Access Compliance Report

Public Rights-of-Way

(Curb Ramps)

Intersection ID: 10023486	Main Street: CIRCUMFERENTIAL_RD	Cross Street: N/A	Location: SE
ADA ID: 3BAFADE1E181	Ramp Type: Perp	Initial Pass/Fail: Pass	Overall Compliance: No
Codes/Mitigation Info/Possible Solution		Field Measurements/Component Compliance	
Severity Score: 2.5

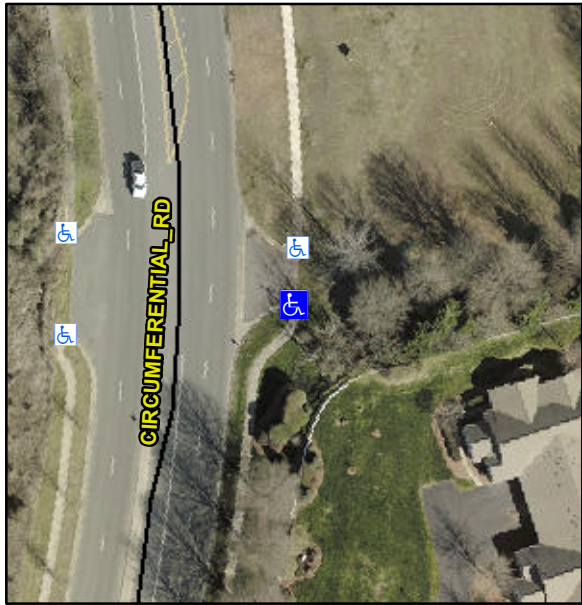
Possible Solutions:		Compliance		Description	Data	Compliance		Description	Data
	Remove & Replace Entire Ramp.		N/A	Ramp Length (in)	28.0	Yes	Ramp Slope (%)	6.2		
	Remove & Replace Gutter.		Yes	Ramp Width (in)	48.0	Yes	Ramp XSlope (%)	0.0		
			N/A	Flare Type LT	None	N/A	Flare Type RT	N/A		
			N/A	Flare Slope LT (%)	N/A	N/A	Flare Slope RT (%)	N/A		
			N/A	Flare Traversable LT?	N/A	N/A	Flare Traversable RT?	N/A		
			Yes	Landing Length (in)	53.0	Yes	DWS Provided?	Yes		
			Yes	Landing Width (in)	48.0	Yes	DWS Contrast?	Yes		
			Yes	Landing Slope (%)	2.0	Yes	DWS Length (in)	24.0		
			No	Landing X Slope (%)	2.4	No	DWS Full Width?	No		
Surveyor Notes: N/A PROW/ADA: R304.5.3, R305.1.4			N/A	Landing Curb? (Y/N)	No	Yes	DWS Offset (in)	1.5		
			N/A	Shared Landing?	No					
			Yes	Gutter Ponding?	No	Yes	Gutter Slope (%)	3.5		
			Yes	Gutter Lip Ht (in)	0.0	No	Gutter X Slope (%)	2.8		
			N/A	Painted X Walk1?	No	N/A	Painted X Walk2?	N/A
